HUMAN FACTORS EVALUATION OF THE
STANDARD NUCLEAR UNIT POWER PLANT SYSTEM
(SNUPPS)

Nuclear Projects, Inc.
5 Choke Cherry Road
Rockville, Md. 20850

Essex Corporation
333 North Fairfax Street
Alexandria, Virginia 22314

From September 1980 to February 1981, the Essex Corporation of Alexandria, Virginia performed a human engineering evaluation of the Standard Nuclear Unit Power Plant System (SNUPPS) for Nuclear Projects, Incorporated. Data were collected from two sources: the Westinghouse simulator at Zion; and the as-built control boards at the Callaway site. The evaluation employed human engineering assessment techniques developed by Essex Corporation specifically for power plant control room design reviews. These techniques were developed while writing NUREG/CR-1580 for the NRC and subsequently were refined during control room reviews for other utilities.

FIGURE 1. A UTILITY'S SPDS INPUT TO ESSEX (SEE FIGURE 2).

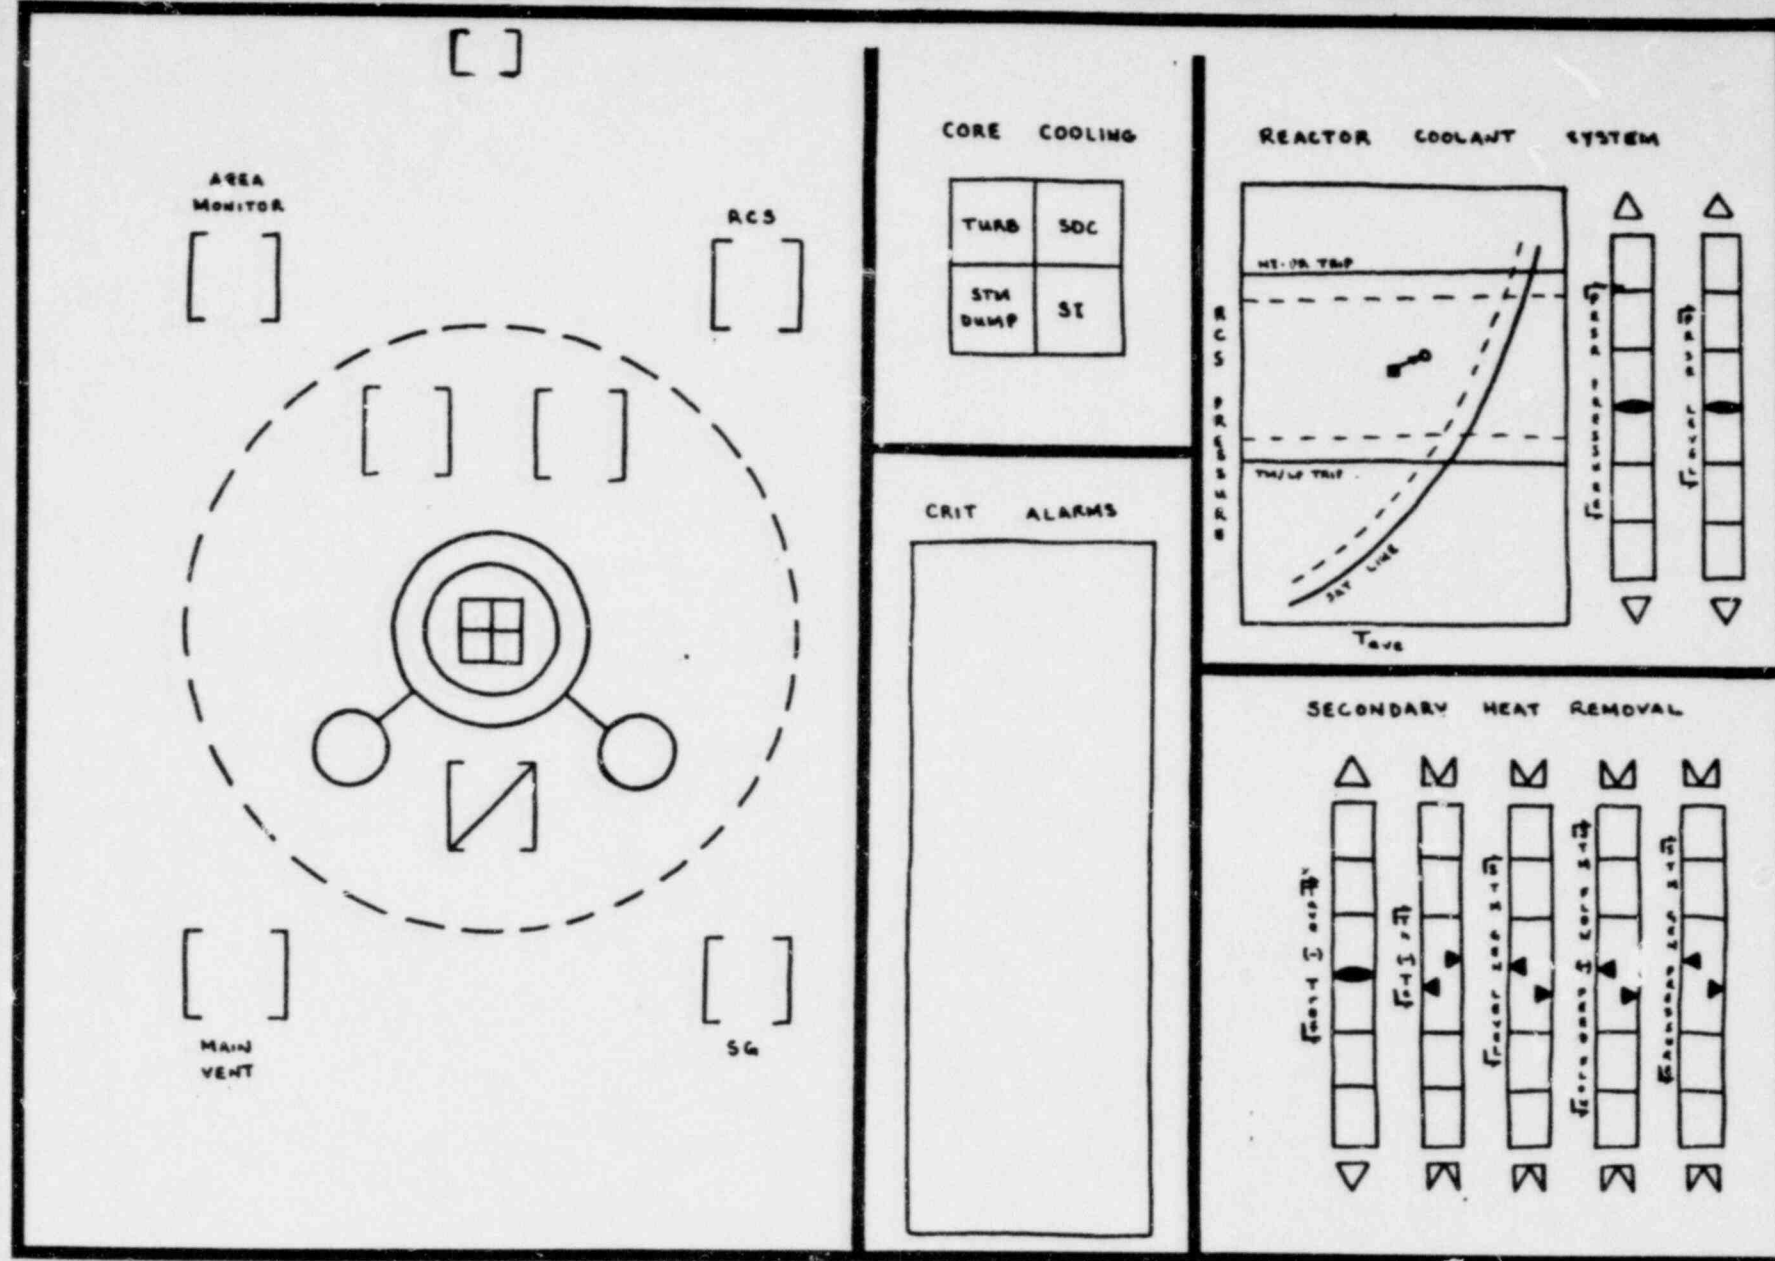
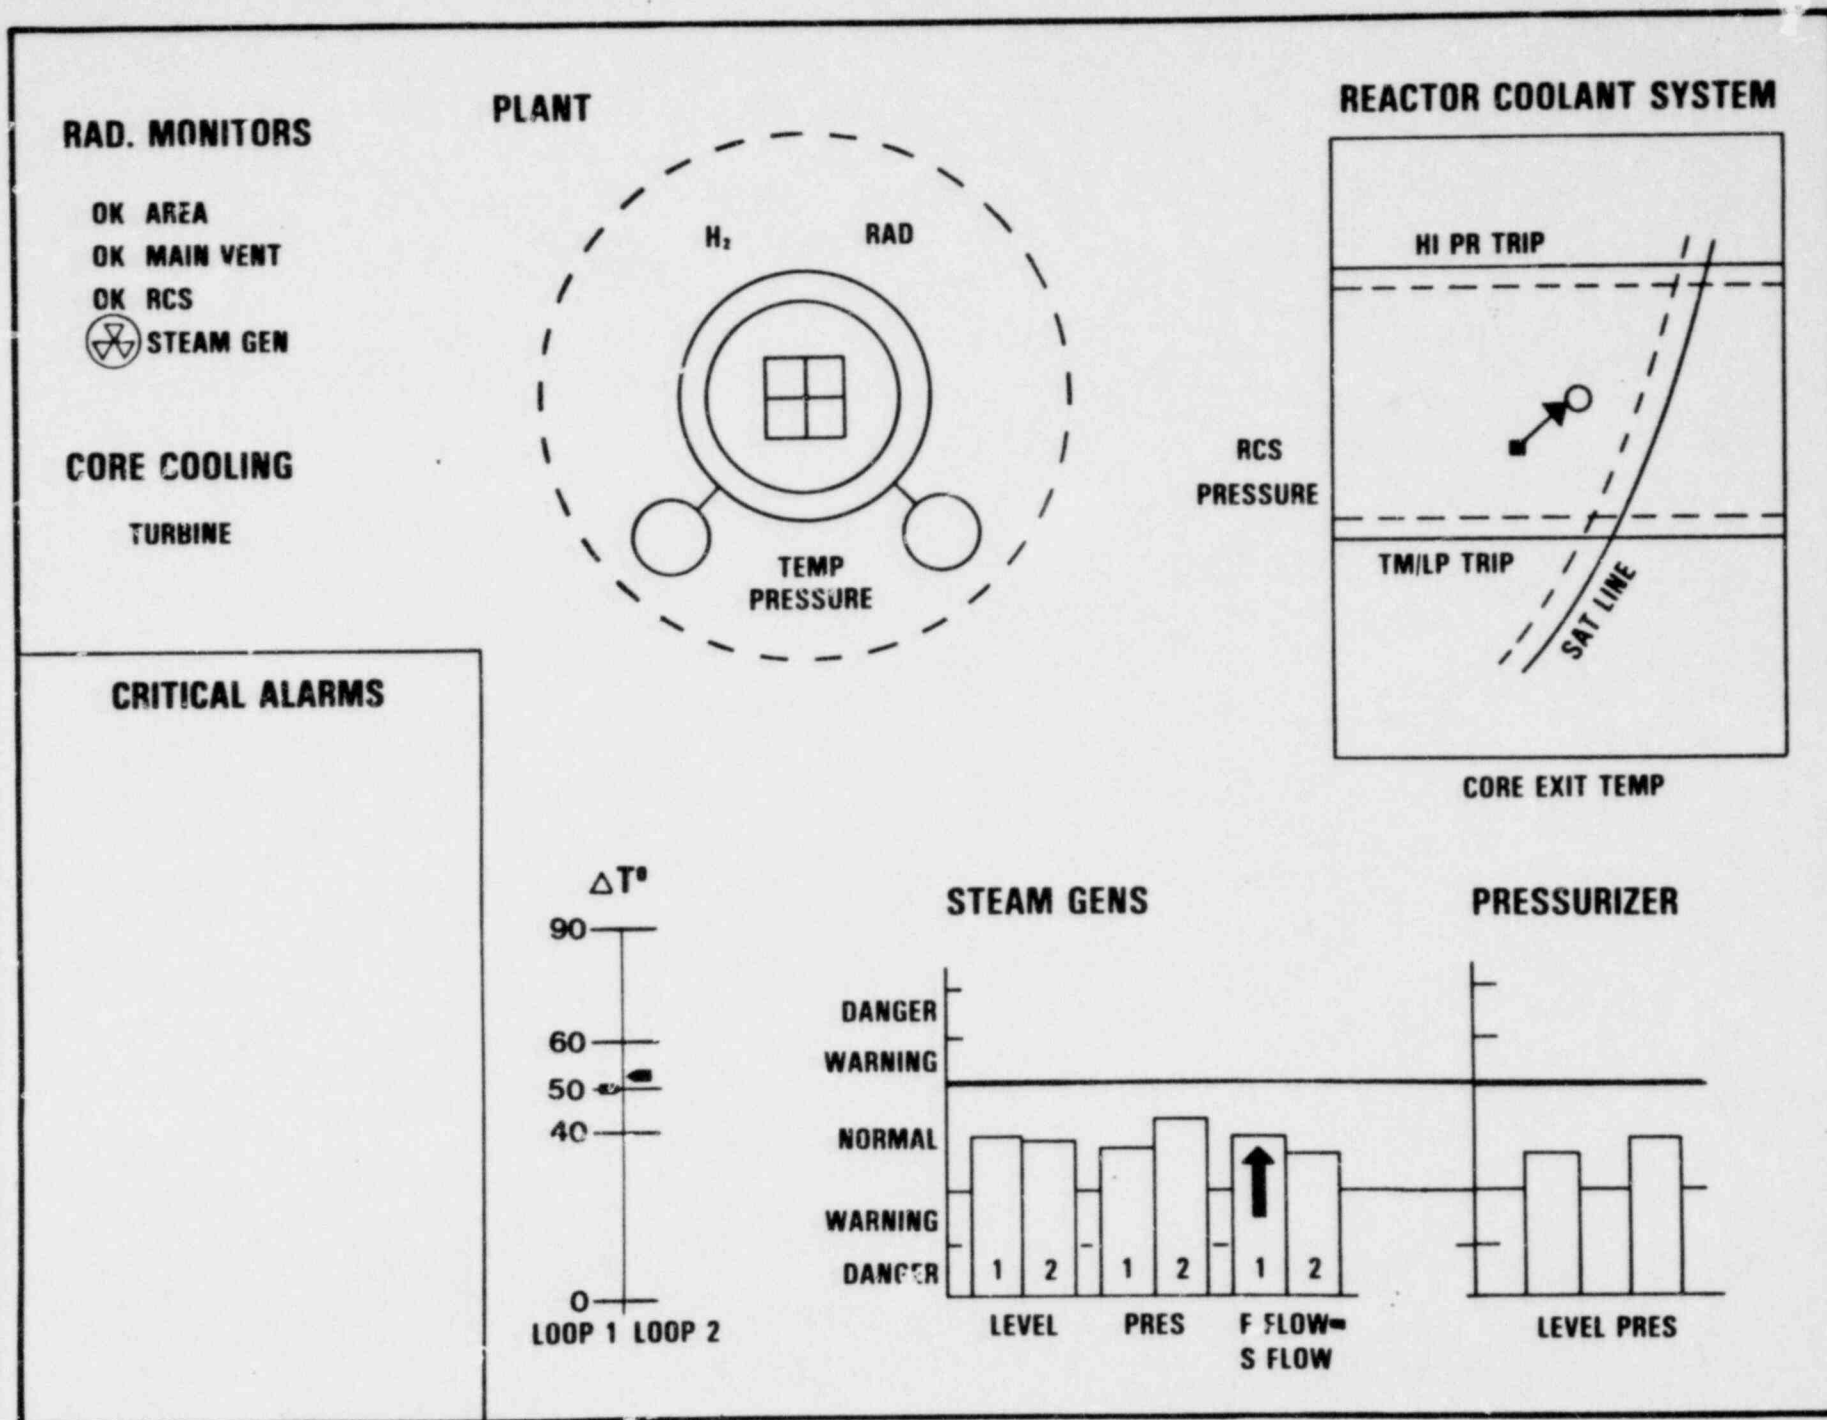
Figure 1 presents a proposed computer-driven single page SPDS display as submitted to Essex by a utility for human factors input. A 19" color graphics CRT is the planned mode of display. Figure 2 presents Essex's revision of the display format. While elaboration of the details and dynamics of each display is not presented here, an examination of the two figures will reveal a regrouping and reformatting of information to simplify the display. These changes were made with the goals of reducing detection time for abnormal conditions and improving operator information extraction. Other recommendation areas included coding methodologies, coding consistency (within the display and between the display and the control room), display resolution, and parameters to be monitored. Further evolution of the display is expected as the SPDS parameter set undergoes final revision and as hardware input is received. For more details on this display, contact Essex Corporation.

FIGURE 2. ESSEX REVISION OF SPDS DISPLAY.

FIGURE 1
LAYOUT OF HOT/COLD LEG TEMPS AND OVERPOWER SET POINT RECORDERS

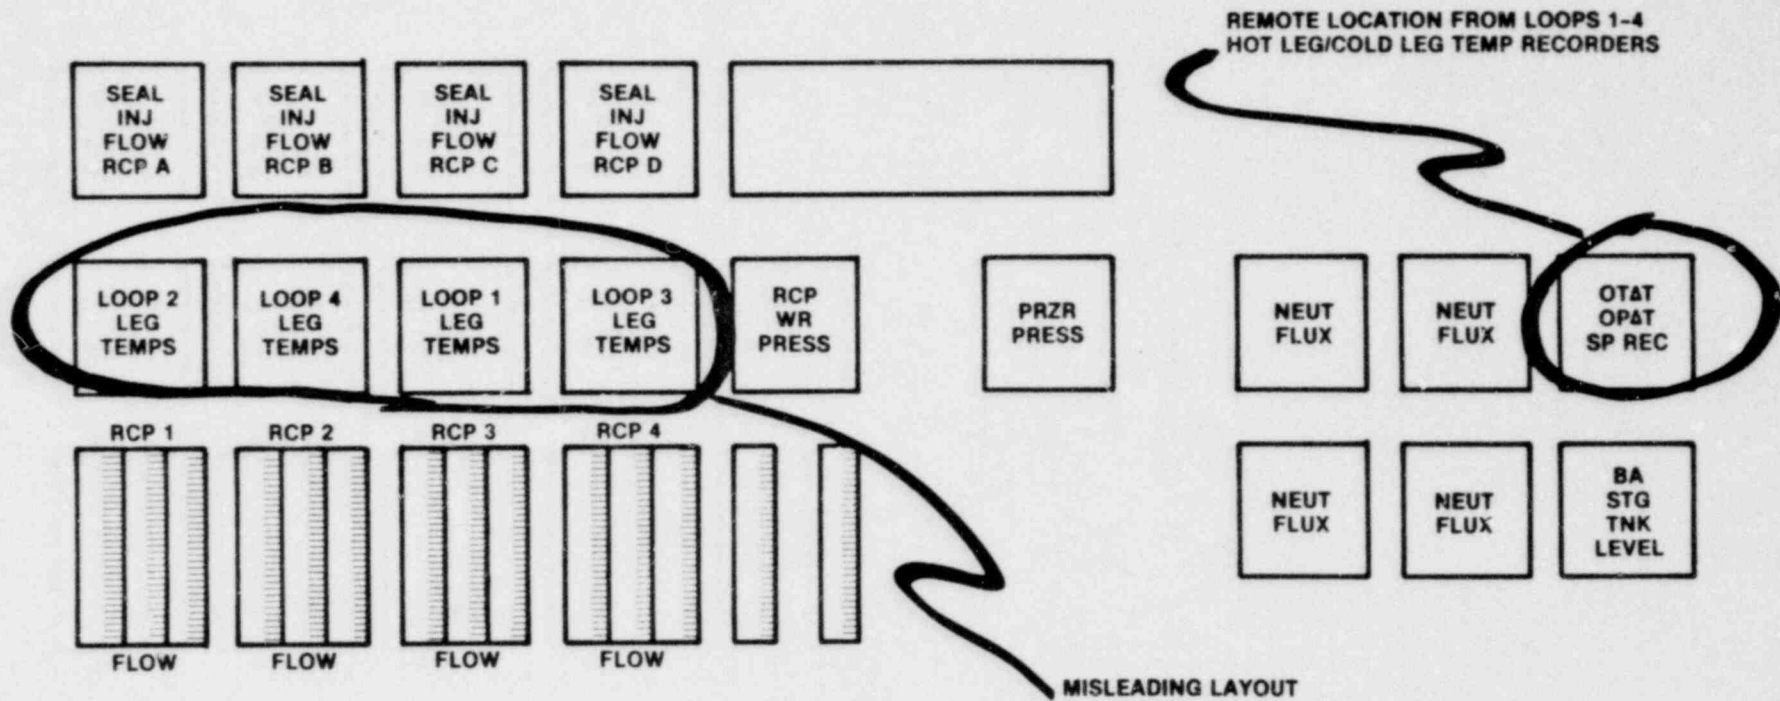
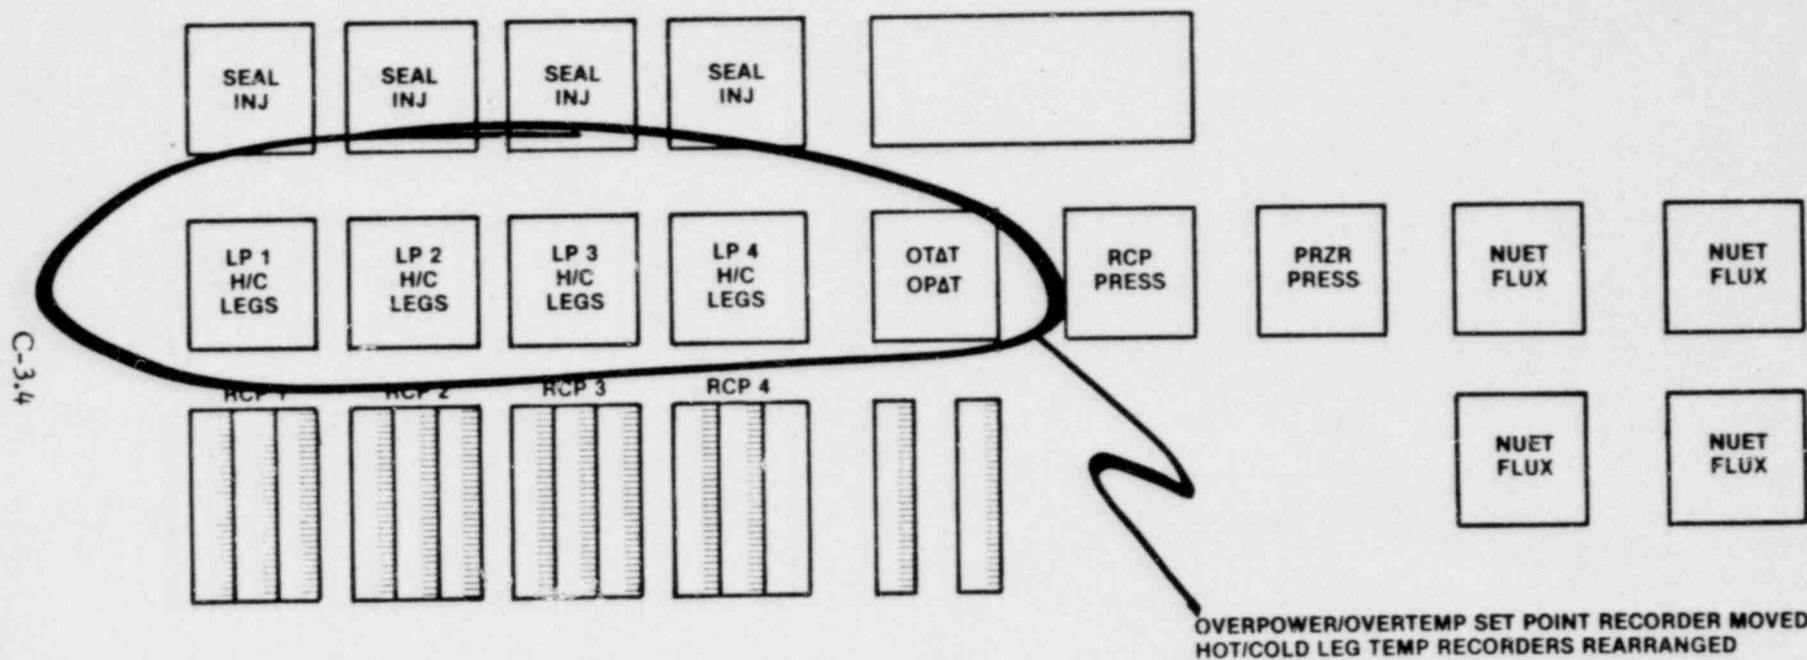
Current layout is shown on Figure 1. A potential rearrangement is demonstrated in Figure 2.

**FIGURE 2
RECORDER REARRANGEMENTS**

BA STORAGE TANK LEVEL MOVED TO CVCS AREA

FIGURE 6

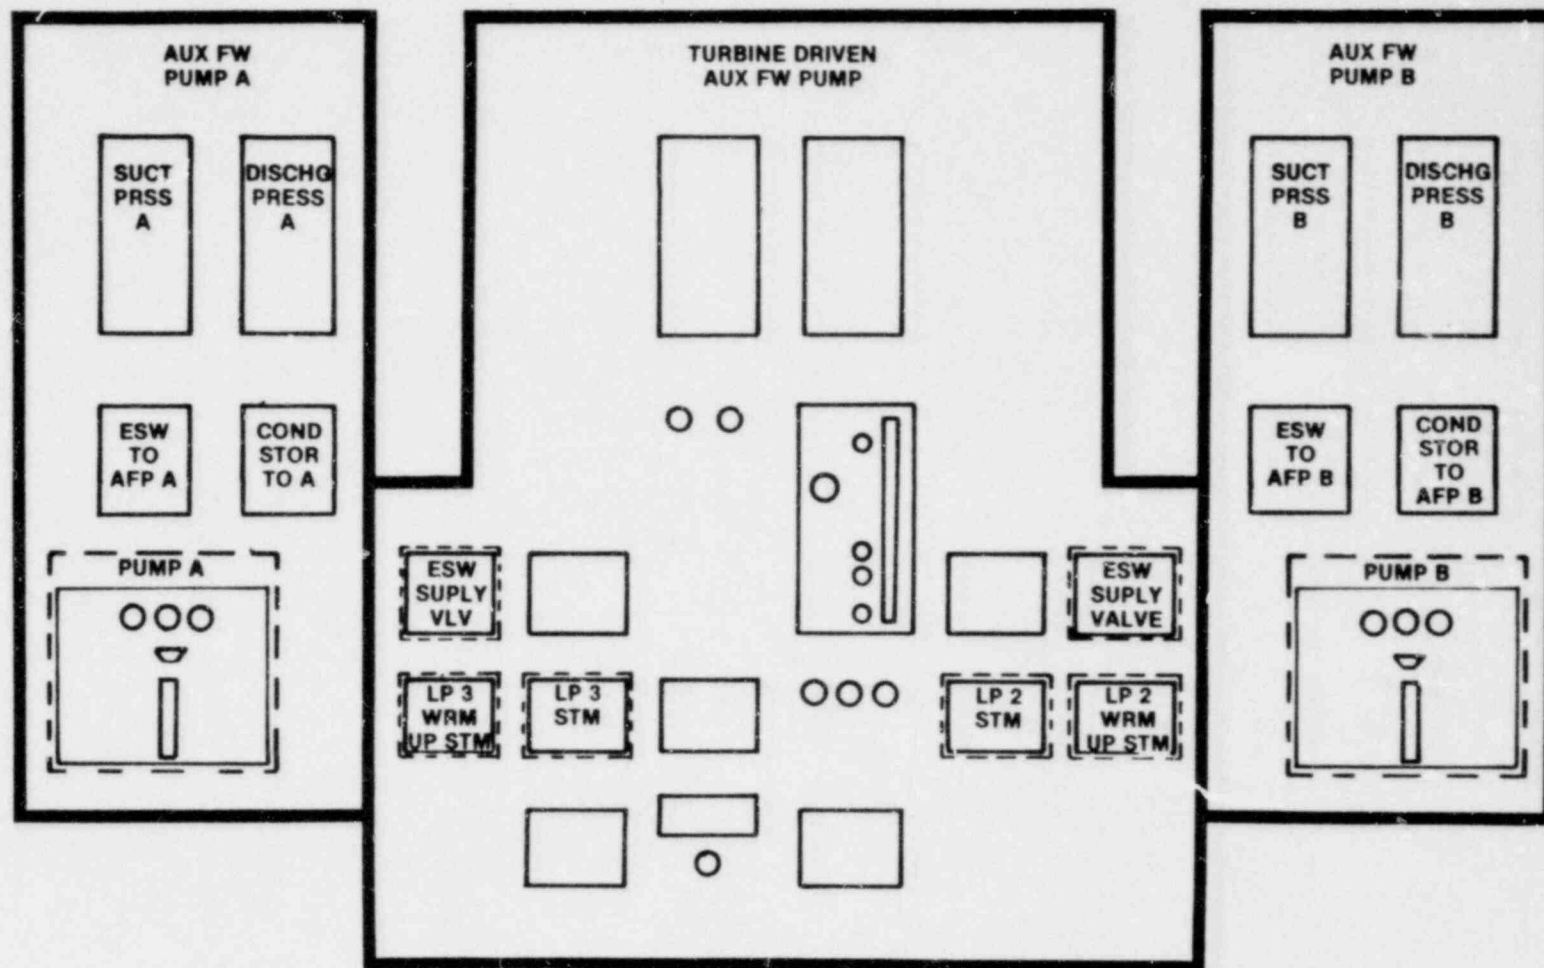
A) Aux FW Pumps. This layout (see Figure 6) appears to be a mirror image design but is not for the motor driven pumps; for the turbine driven aux feed pump, only the loop 2 and 3 steam supply valves and ESW supply valves are mirrored. The following recommendations regarding these problems are ranked in order of preference.

AUX FW SYSTEM IS VISUALLY SYMMETRICAL, BUT NOT COMPLETELY MIRRORED IN CONTROL/DISPLAY FUNCTIONS. ADDITIONS OF DEMARCATION LINES (HEAVY LINES) WILL HELP TO SHOW GROUPS, BUT ADD TO SYMMETRY. CONTROLS OUTLINED IN DASHED LINES ARE MIRRORED FUNCTIONS.

1. Completely redesign the layout of the AUX FEED system in a manner that does not create the illusion of mirror imaging (see example in Figure 7).
2. Rearrange components in AUX FEED to eliminate all incidences of mirror imaging, and move PUMP B breaker control to the left, so as to be positioned

3. Demarcate as shown in Figure 6, and provide switch guards over steam supplies and ESW supply for the TURBINE DRIVEN AUX FEED PUMP. This solution to the mirroring problems is not highly regarded since it only partially ameliorates the problems and introduces others (e.g., limiting switch access).

FIGURE 8
MODERATE REARRANGEMENT OF AFWP SYSTEM WITH FUNCTIONAL DEMARCATIONS

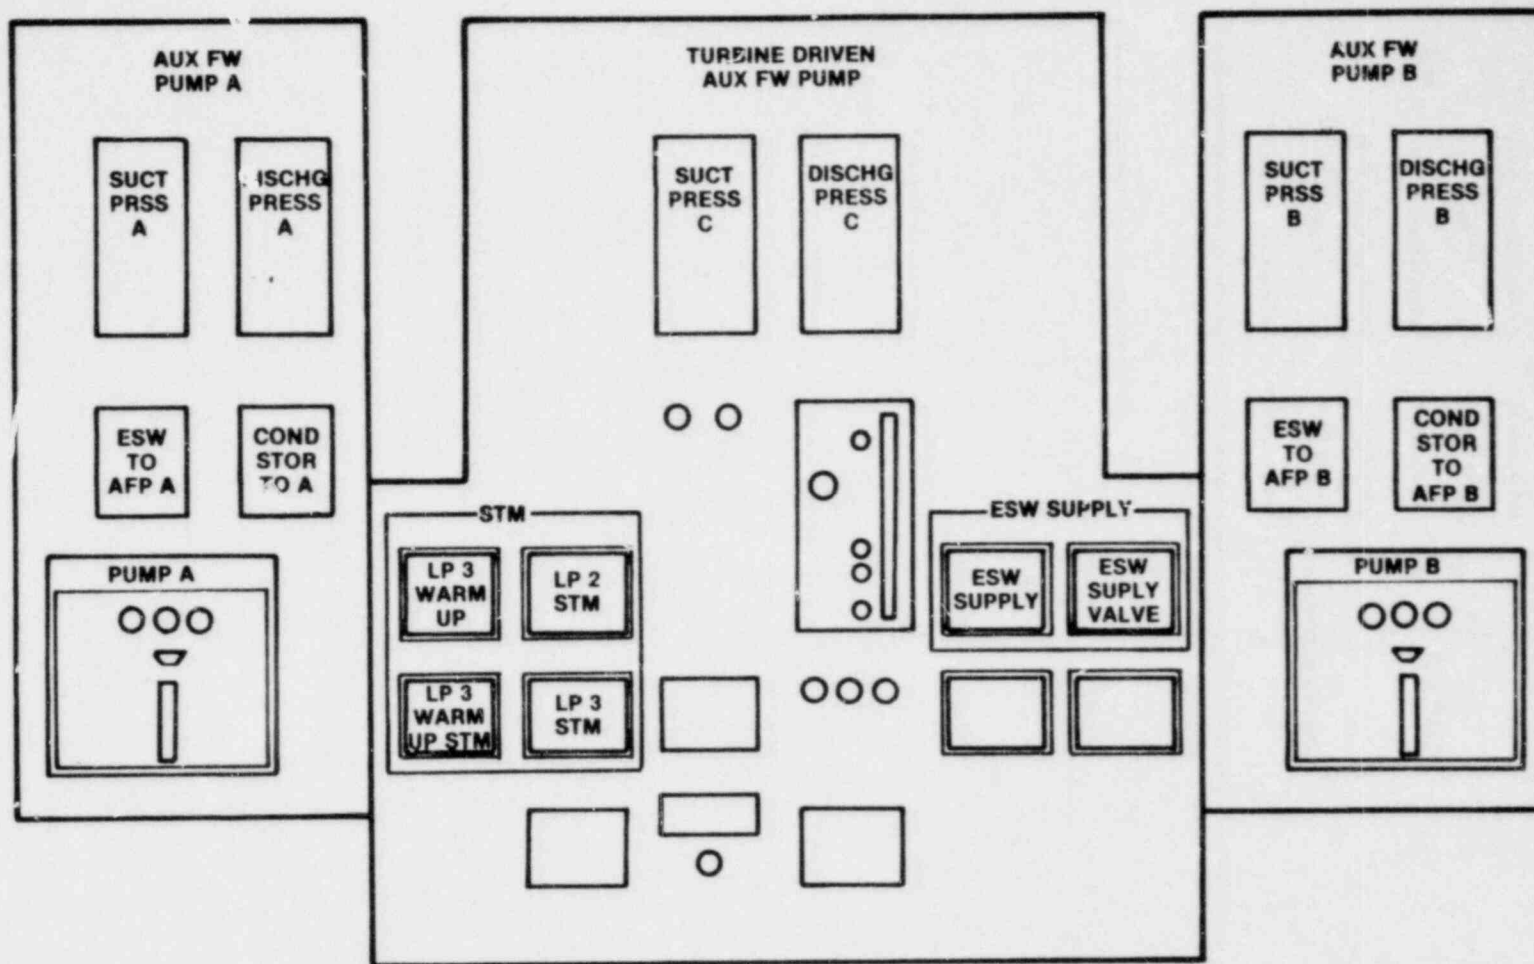
as PUMP A breaker control, thereby reducing the appearance of mirror imaging. Also, add lines of demarcation to visually break up respective pumps (see Figure 8).
